# **802.3ck D1.4**

## **Annex 162B – Test Fixtures**

### **RL, ERL and FOM<sub>ILD</sub> Comments**

**Chris DiMinico**  
MC Communications/PHY-SI LLC/Panduit  
[cdiminico@ieee.org](mailto:cdiminico@ieee.org)

# Proposal Mated Test Fixture ERL

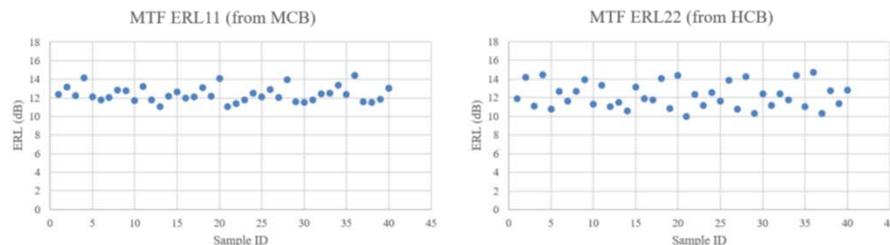
- 162B.1.3.2 Mated test fixtures effective return loss (ERL) - P262, L43, TBD = 10.3
- 162B.1.3.2 Mated test fixtures effective return loss (ERL)

The mated test fixture ERL shall be greater than or equal to **TBD** dB.

- 40 new data points collected using are QSFP-DD800, with fixtures that implement the latest MSA changes
- All data points meet previous proposal of 8dB for MTF ERL and would also meet a 9dB requirement
  - [ 9.8dB , 14.7dB ]

# Proposal Mated Test Fixture FOM<sub>ILD</sub>

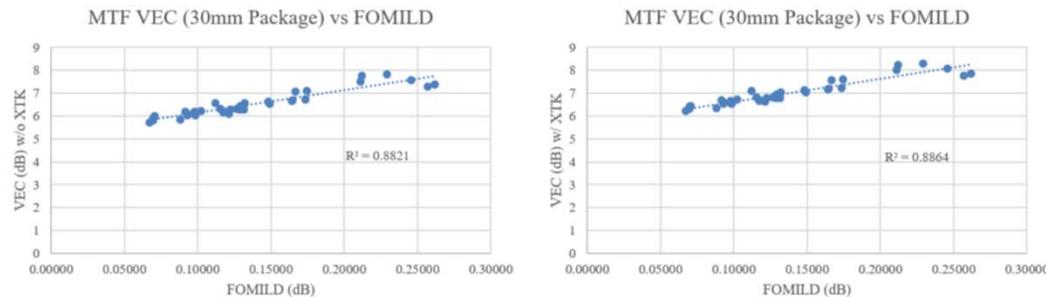
- 162B.1.3.1 – P262, L36, TBD = 0.18, Tr=9.6 ps
- Update PICs.

The FOM<sub>ILD</sub> is calculated according to 93A.4 with  $f_b=53.125$  GHz,  $T_i=7.5$  ps, and  $f_r=0.75 \times f_b$ . The fitted insertion loss and insertion loss deviation are computed over the range  $f_{min}=0.05$  GHz to  $f_{max}=40$  GHz. FOM<sub>ILD</sub> shall be less than (TBD) dB.

- Adding maximum crosstalk to the MTF results in ~ +0.5dB VEC
- VEC and FOMILD are well correlated and VEC<7.5dB results in and FOMILD<0.187dB
- Recommend setting the MTF FOMILD requirement to 0.18dB for D1p5 release
  - Can be adjusted in future drafts if VEC requirements change or more MTF data becomes available

Table 162–10—Summary of transmitter specifications at TP2

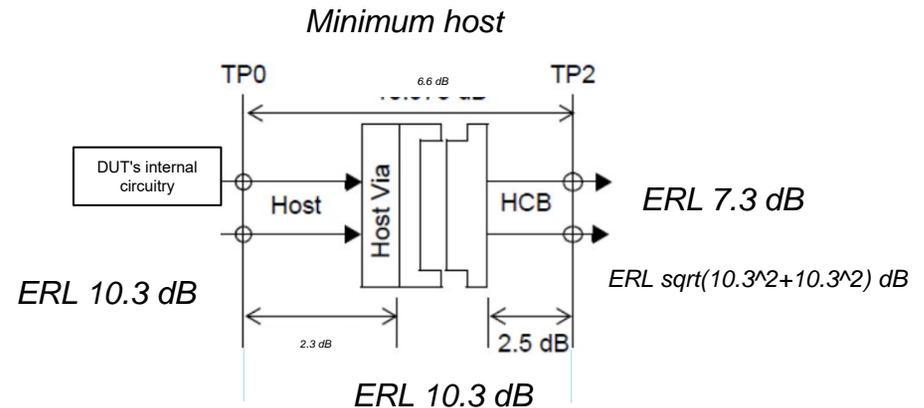
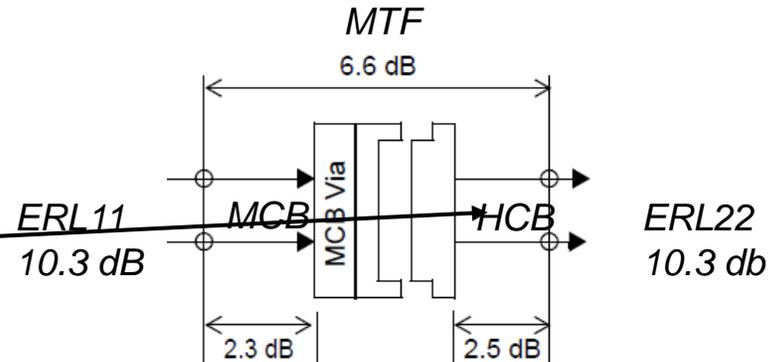
"The mated test fixture ERL shall be greater than or equal to TBD dB"

We have adopted a minimum of 7.3 dB for a host ERL in Table 162–10 (with parameters in 162.9.3.5). The parameters for MTF are the same, except that "Time-gated propagation delay" is 0 instead of 0.2 ns.

The value 0 was accepted explicitly (comment #122 against D1.3) but the difference does not seem to be justified, since the MTF includes the test fixture used for host ERL measurement (where the connector is time gated). Different time gating creates difference in the meaning of ERL.

The ERL from a high-quality MTF is the upper bound for any measurement of a DUT which uses any one of the test fixtures. Therefore, it should be significantly higher than 7.3 dB.

It is suggested to divide the budget evenly to allow about the same reflection power from the DUT's internal circuitry as from the mated connectors; if each one is 10.3 dB then their combination (RSS, since reflections are independently distributed) would be 7.3 dB.

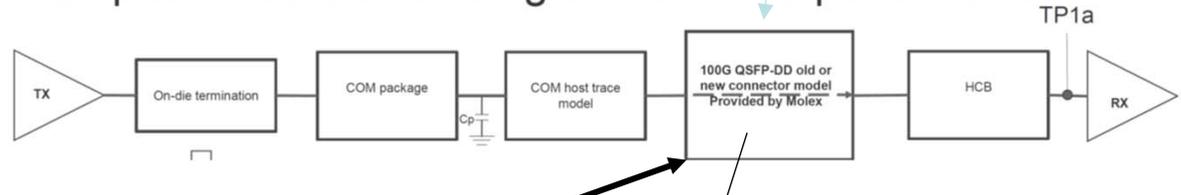
The ERL of the mated test fixture should be significantly better than the specification for the ERL of the device under test. The ERL of the QSFP-DD improved connector used for channel modeling in e.g Didel\_3ck\_01\_0320. has an ERL of 15.7 dB.

Request MTF ERL of 14 dB

# Rise time

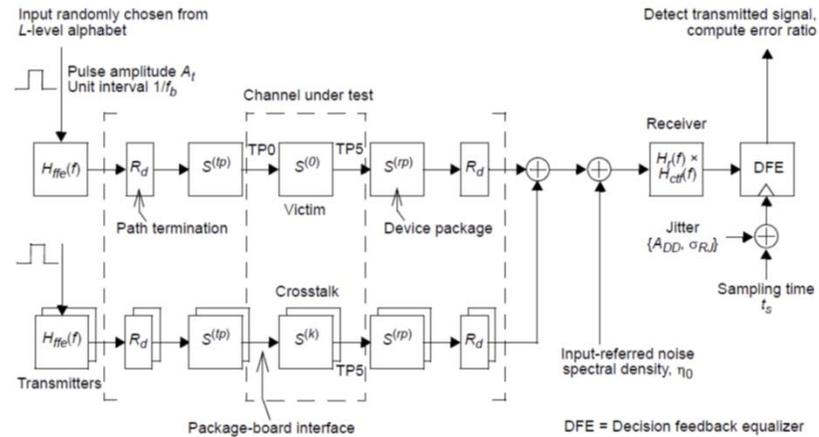
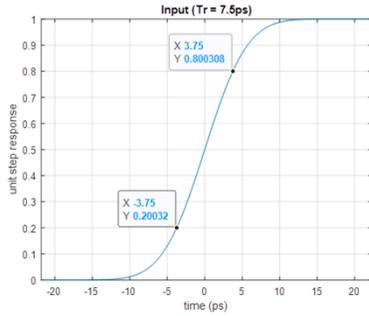
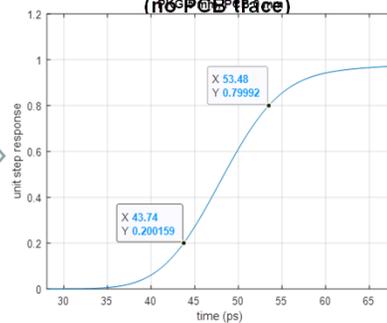
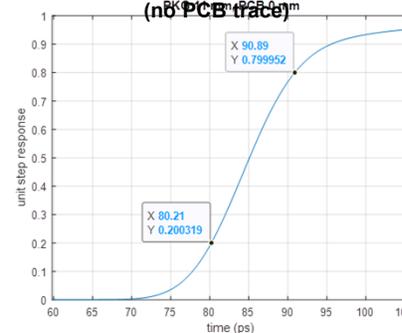
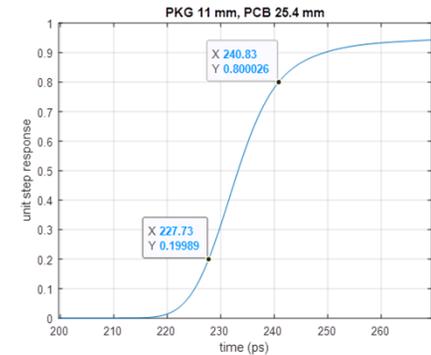
$Tr\ COM = 7.5\ ps$

7.5ps input step (Gaussian input pulse)

9.74ps after 5mm PKG trace (no PCB trace)

10.68ps after 11mm PKG trace (no PCB trace)

13.10ps after 11mm PKG trace and 25.4mm PCB trace
